TECHNICAL SERVICE BULLETIN

ISSUE DATE:	5/26/2022
SERVICE BULLETIN SUBJECT:	35 Foot ZX5 Horn Relay Retrofit
VINs or MODELS AFFECTED:	Service Specified Buses
COMPLETE BY:	Next Service Opportunity
SERVICE BULLETIN #:	SC-22-64
LABOR OPERATION CODE:	N/A

35 FOOT ZX5 HORN RELAY RETROFIT

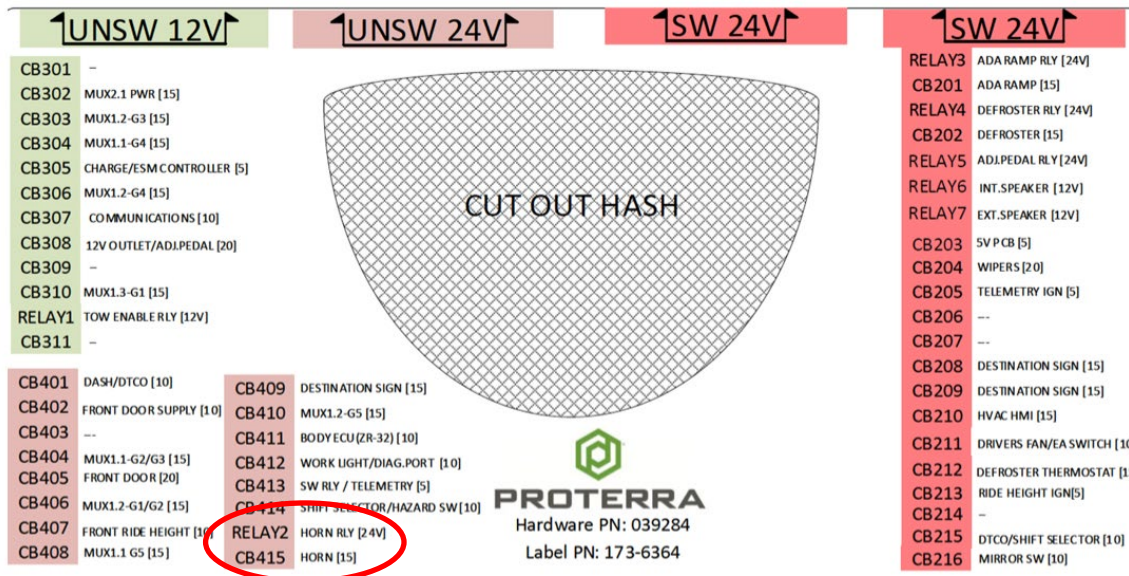
This procedure updates the horn relay and circuit breaker to more robust versions.

3. Remove the VEC cover.
4. Using the new VEC Label as a guide, locate RELAY2 and CB415. These parts are shown circled in red below.

5. Using the Yellow Tool provided inside the VEC, replace RELAY2 (**128-2640**) and CB415 (**013529**) with the new ones from the kit.
6. Remove the installed Label from the VEC.

- 061509 Kit, Service, 35' ZX5 Horn Relay Retrofit (Consisting of)
 - 128-2640 RELAY, ULTRA MICRO, 24V DC COIL, 30A CONTACT 1 EA
 - 013529 CIRCUIT BREAKER, COOPER BUSSMAN, 15AMP 1 EA
 - 173-6364 LABEL, ELECTRICAL CENTER, ECAB 1 EA
